## PRODUCT/PROCESS CHANGE NOTICE (PCN)

<b>PCN #:</b> TB-0609-02 <b>DATE:</b> 06-Oct-2006 <b>Product Affected:</b> SOJ 28L, 32L, 36L Products shipped in tube  <b>Date Effective:</b> 06-Jan-2007	<b>MEANS OF DISTINGUISHING CHANGED DEVICES:</b> <input type="checkbox"/> Product Mark <input type="checkbox"/> Back Mark <input type="checkbox"/> Date Code <input checked="" type="checkbox"/> Other                      Rev. 08 printed on shipping tube
---	---

### ATTACHMENT I - PCN #: TB-0609-02

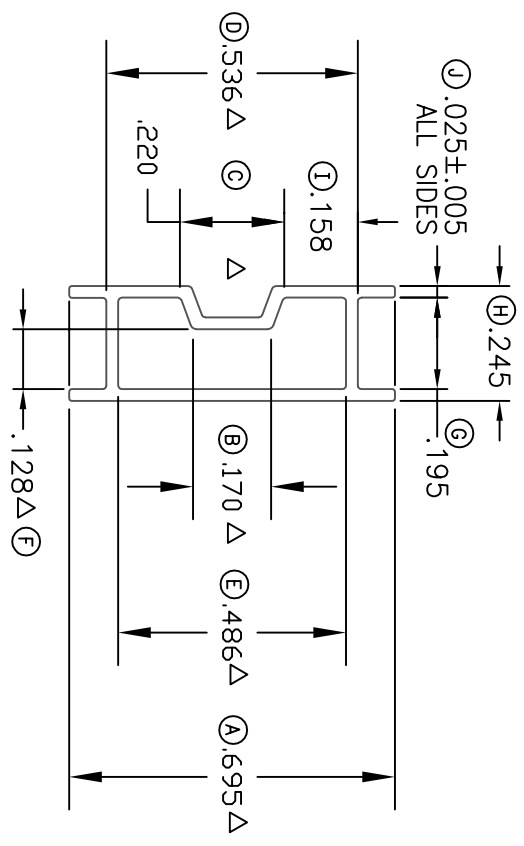
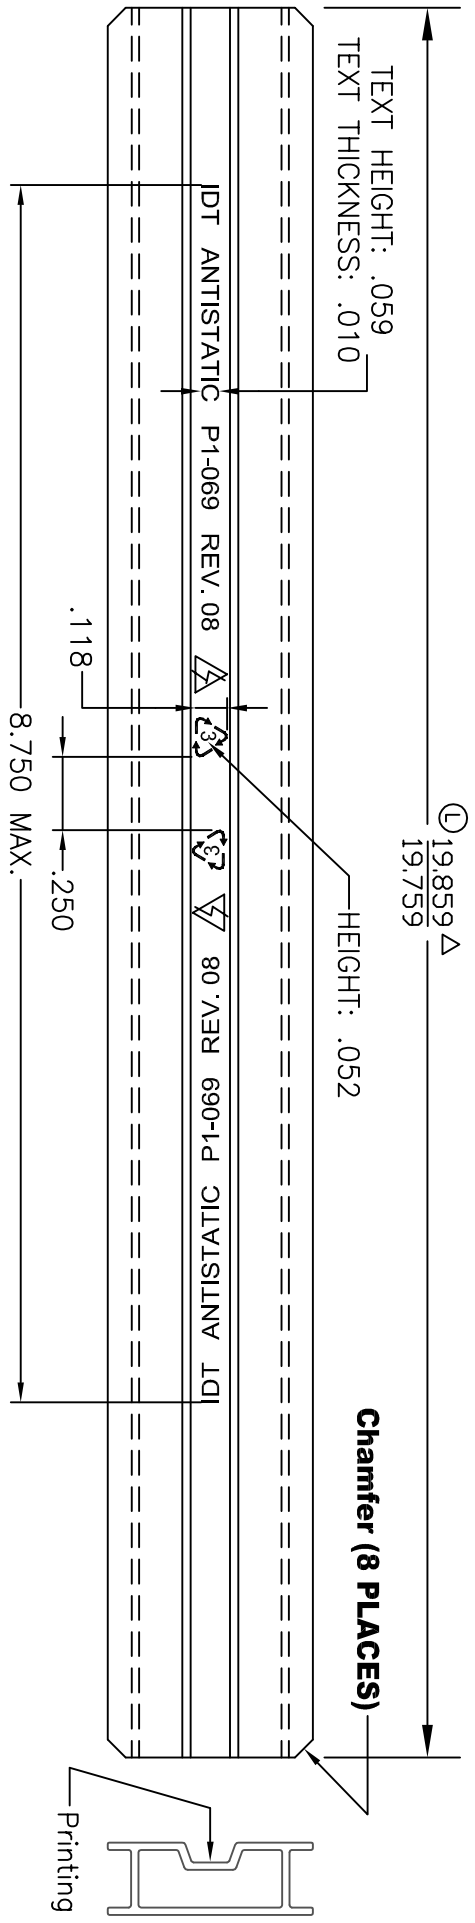
**Detail of Change:** This notification is to advise our customer that IDT has qualified new shipping tubes for SOJ 28L, 32L, 36L products. The new shipping tubes have an increase in the tube opening height from 0.105 inches to 0.128 inches to provide better protection for packages during assembly, test and backend processes.

*\* Note: Tube opening height is denoted as dimension 'F' in the tube drawing. See attachment for the drawing.*

REVISIONS			
REV	DESCRIPTION	DATE	APPROVED
13	INCLUDED ITW MERITEX AS SUPPLIER	03/11/06	KK Three
14	INCREASE (F) FROM 0.105" TO 0.128"	08/24/06	KK Three

Description	Existing Shipping Tube	New Shipping Tube
Supplier	ITW Meritex	ITW Meritex
Supplier Part Number	O-XT0687 Rev 07	O-XT0687 Rev 08
IDT Part Number	P1-069-000 Rev 07	P1-069-000 Rev 08
Revision Printed on Tube	Rev. 07	Rev. 08
* Tube Opening Height (inches)	0.105	0.128
